SERVICE BULLETIN

ENGINE - LP COMPRESSOR - MOVE THE MARK OF THE LASH VALUE ON THE PTO PINION BEVEL
GEARSHAFT - CATEGORY CODE 6 - MOD.ENG-72-0270

V2500-ENG-72-0270

Move the mark of the Lash Value on PTO Pinion Bevel Gearshaft
Fig.1

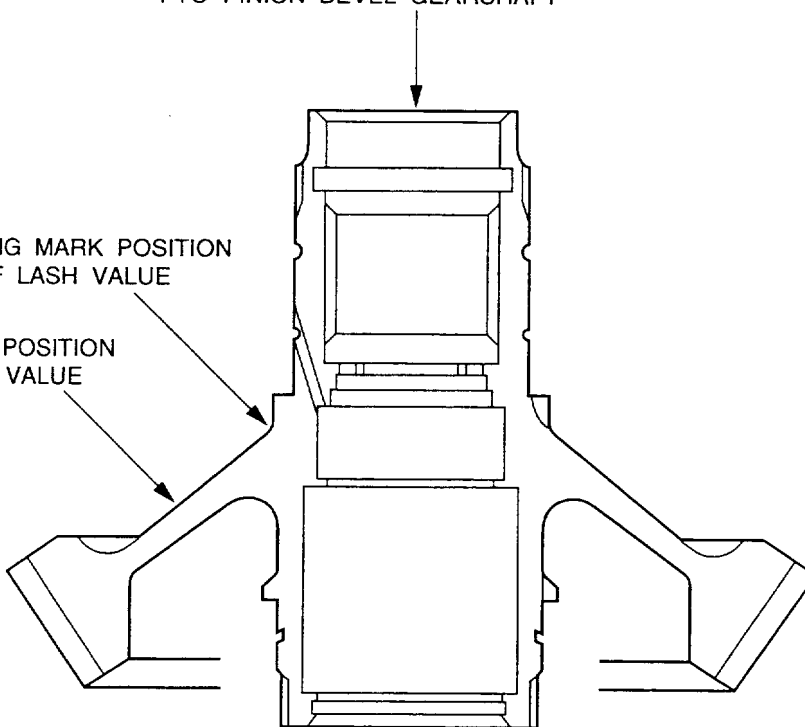
The mark of the lash value at the existing position on the PTO Pinion Bevel Gearshaft is not readable in the assembled condition.

This Service Bulletin instructs to move the mark of the lash value on to a new readable position on the PTO Pinion Bevel Gearshaft.

(a) Find the existing mark of the lash value on the PT0 Pinion Bevel Gearshaft. (Refer to Figure 1)

(b) Make the mark of the same lash value on to a new readable position as shown in Figure 1.

EXISTING MARK POSITION
OF LASH VALUE

NEW MARK POSITION
OF LASH VALUE

Use the vibration peening method (Refer to Reference (2), TASK No. 70-09-00-400-501).

(c) Cancel the existing mark by two solid lines.

(d) Remove raised metal (Refer to Reference (2), TASK No. 70-09-00-400-501).

MOVE THE MARK OF THE SAME LASH VALUE AS
THE EXISTING ONE ON TO THE NEW READABLE
POSITION BY VIBRATION PEENING METHOD.
